BURLINGTON DEVELOPMENT REVIEW BOARD

Tuesday October 7, 2014

TO: Development Review Board
FROM: Scott Gustin 
DATE: October 7, 2014
RE: 15-0339VR; 31 North Avenue

Request: Variance from front yard setback on existing vacant lot.

1 FRONT ELEVATION
1/8"=1'-0"

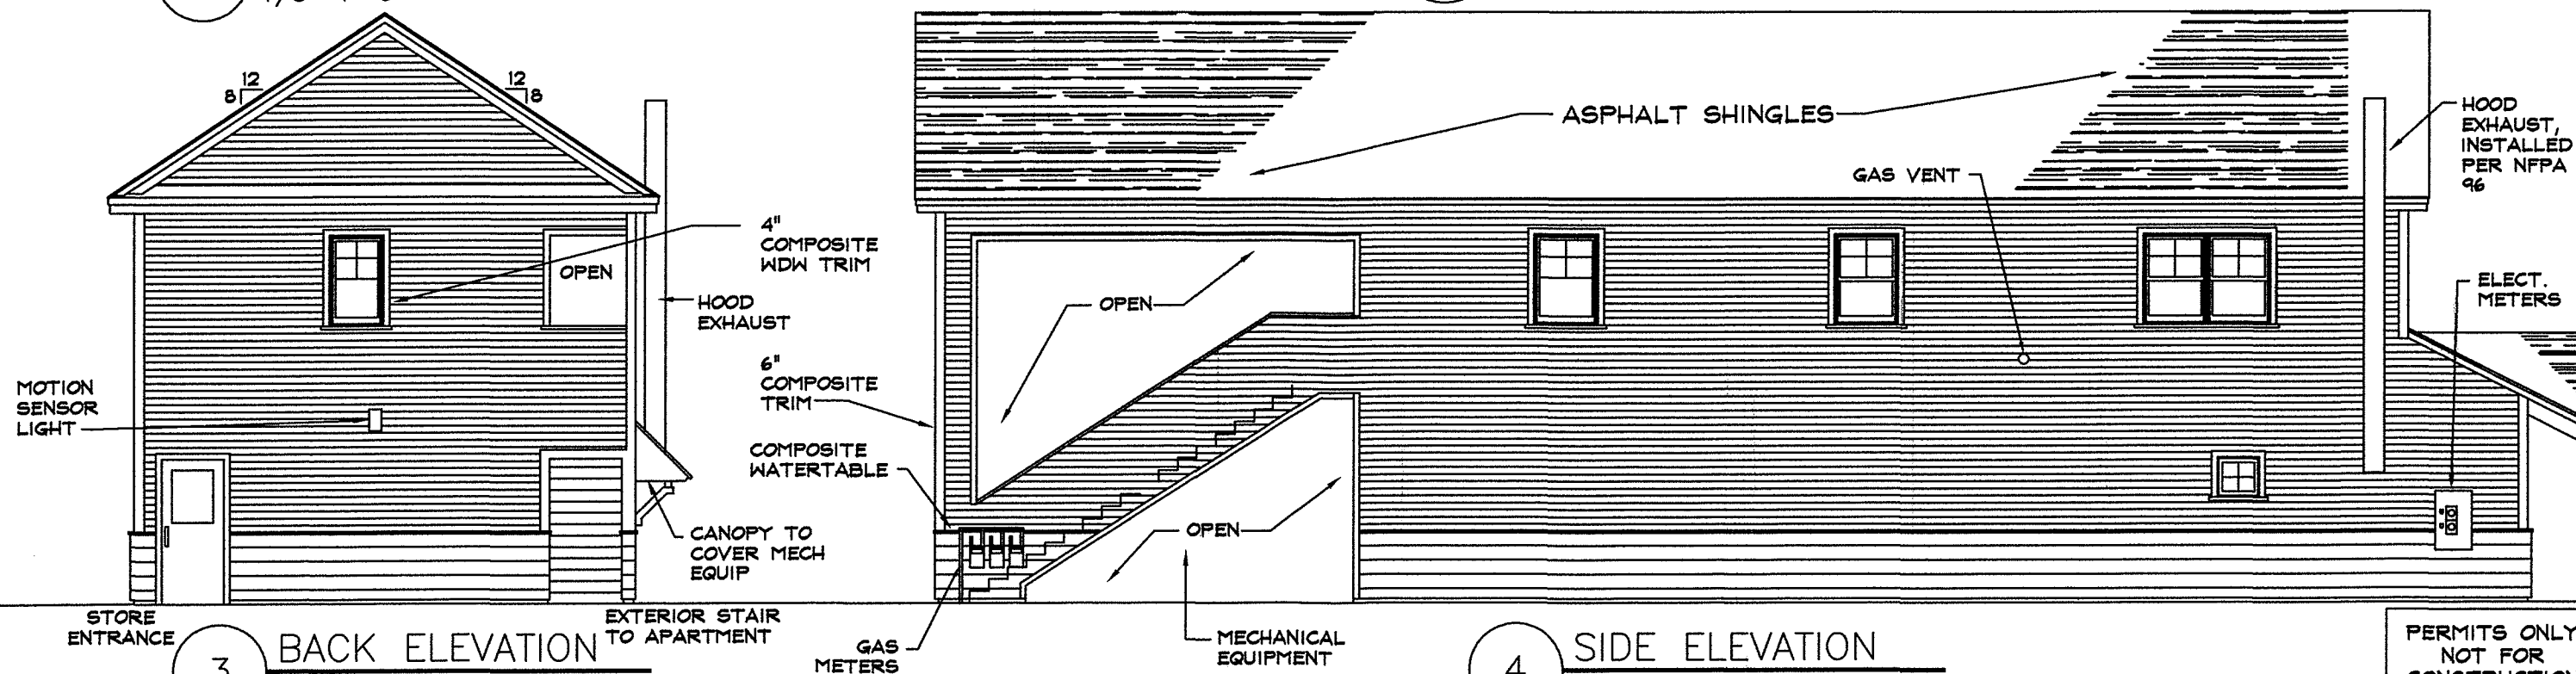
The front elevation plan indicates the location for a future sign. This location and area appear to be able to meet the sign standards. Any signs are required to obtain approval of a separate zoning permit. **Affirmative finding as conditioned.**
